HOUSTON PLANNING COMMISSION

AGENDA

THURSDAY, DECMBER 3, 2020 2:30PM

<u>Platting Summary</u> <u>Houston Planning Commission</u> <u>PC Date: December 03, 2020</u>

Subdivision Name: Villages of Pine Ridge GP

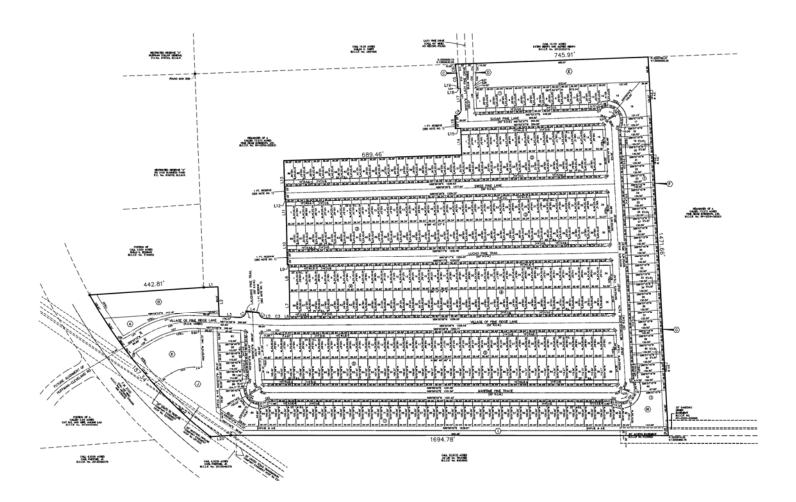
Sugar Pine Lane is a duplication of sugar Pine Drive. Change street name. (chapter 41)

Show east-west stub street at NE portion of plat (Chapter 42)

Subdivision Name: Amira Sec 19

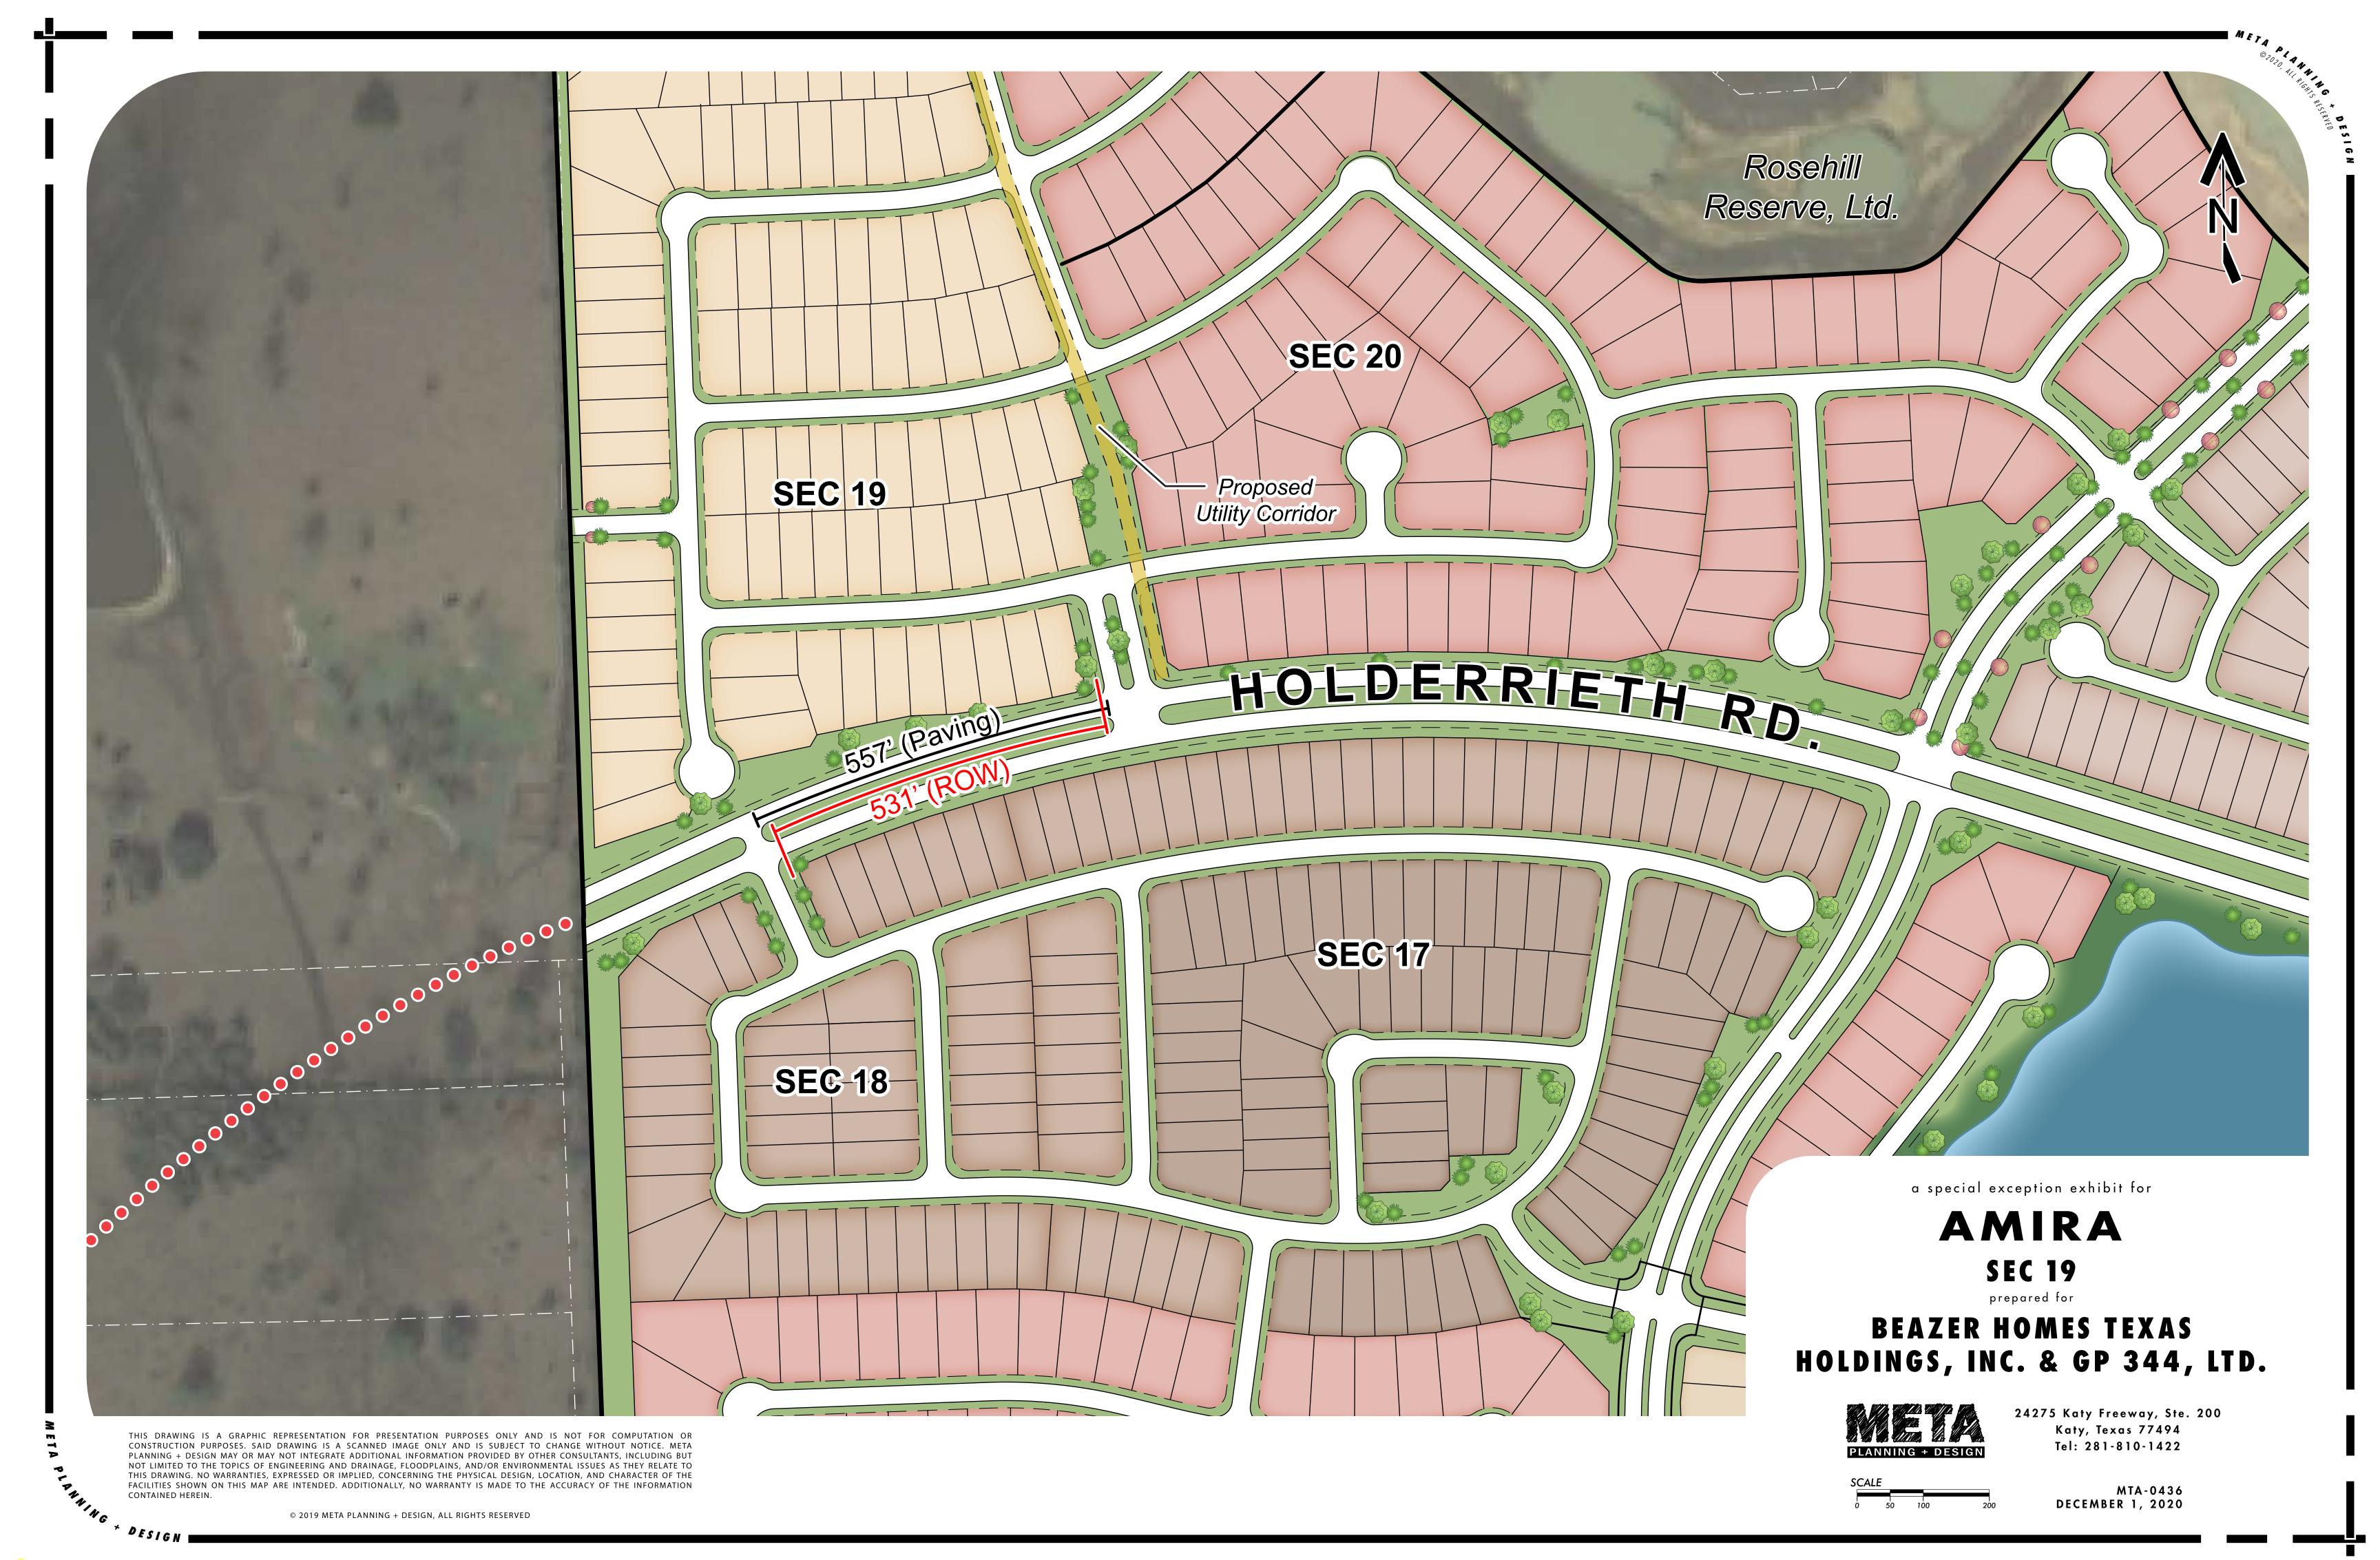
UVE should be checked at Buckeye Brush Rd and Sundown Prairie Dr (Chapter 10-COH geometric design guidelines, 10-23)
